Architect's Supplemental Instructions

PROJECT: *(name and address)*
Wilma P. Mankiller Health Center
Expansion
Stilwell, OK

ASI INFORMATION:
ASI Number: Bid Package 01 - ASI 003

Bid Package 01- ASI 03 – Wilma P. Mankiller Health Center Expansion

SHEET NUMBER: S1.01

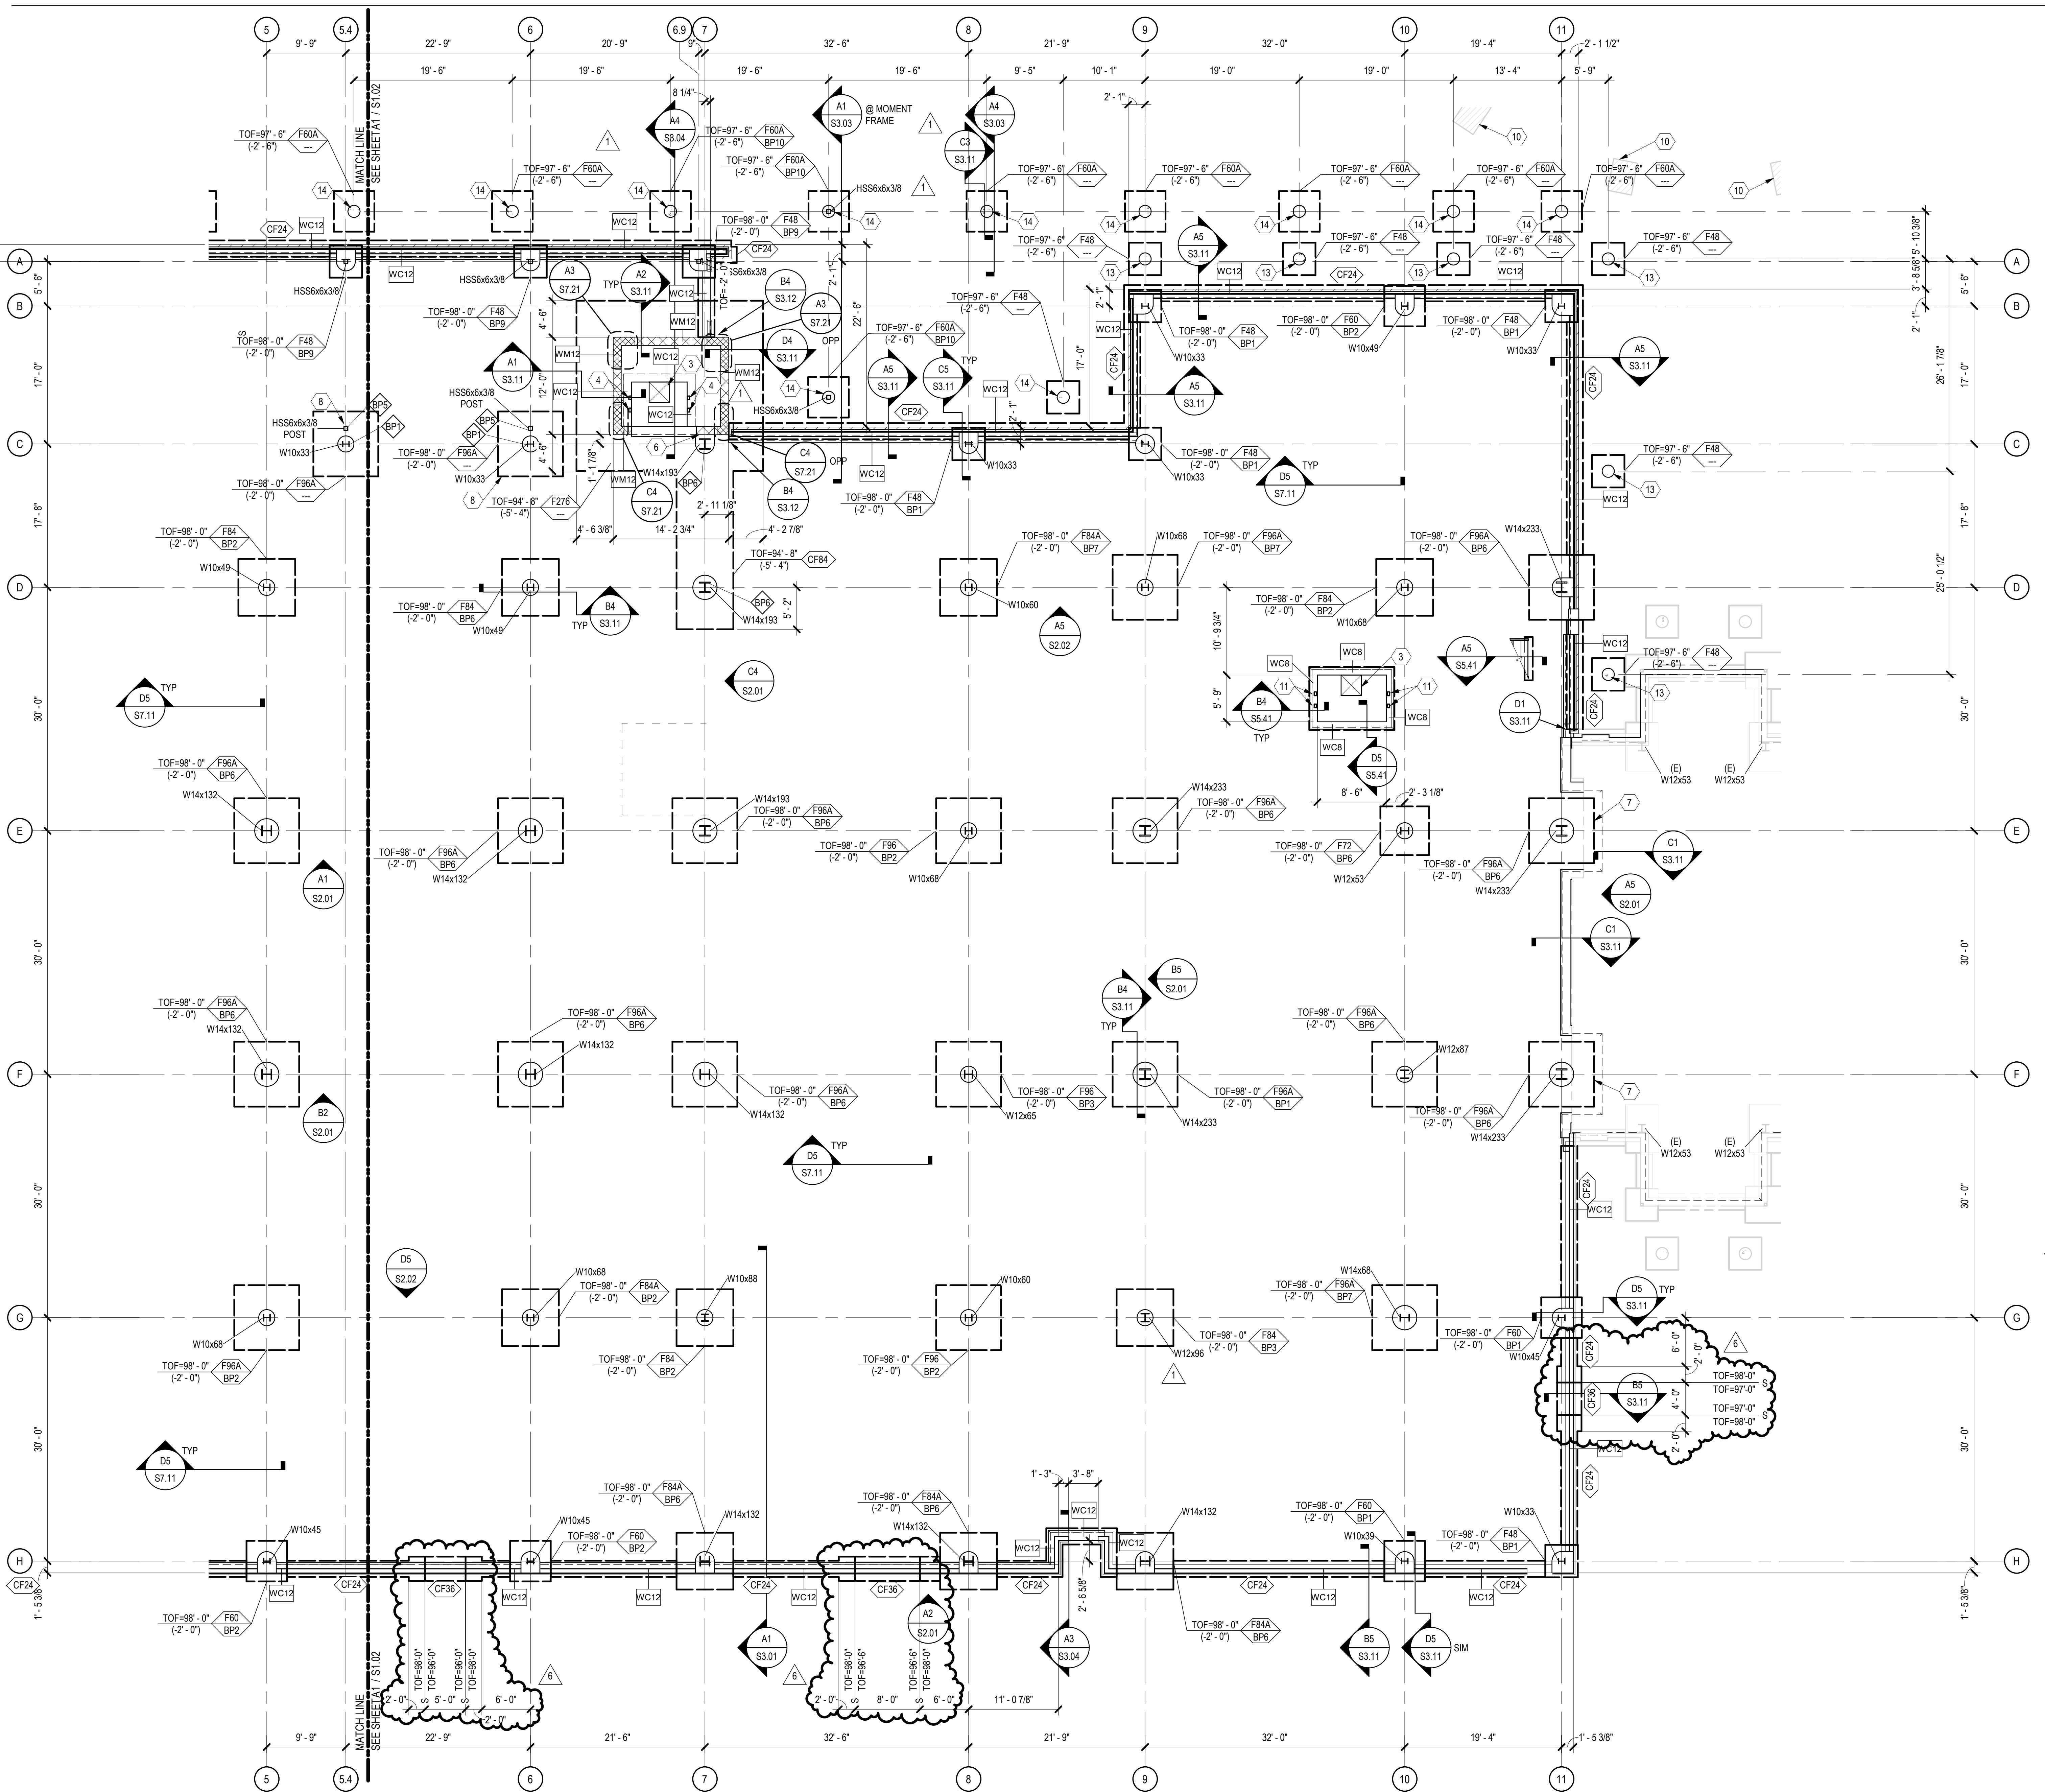
<u>Sheet</u>	<u>Description</u>
S1.01	Keynotes 18, 19, and 20 added.
S1.01	Footing steps added along grids 11 and H to accommodate plumbing lines.
S1.02	Keynotes 18, 19, and 20 added.
S1.02	Footing steps added along grids H, G, and 1 to accommodate plumbing lines.
S1.02	Spread footings dropped along grid 1 to not induce surcharge load on adjacent site retaining wall.
S1.02	Footings supporting precast concrete columns near grid 1 deleted and now supported by site retaining wall pedestal.
S1.02	Site retaining wall outline added for clarity.
S3.11	Sections C3 and D2 updated.
S3.12	Sections A5 and B5 updated.
S3.12	Sections A2, B2, C2, D2, C3, and D3 added.
S4.01	Keynotes 18, 19, and 20 added
S4.01	Spread footings at grid intersections P1/PB and P1/PC updated to not conflict with site retaining wall .
S6.01	Spot footing and continuous footing schedules updated.
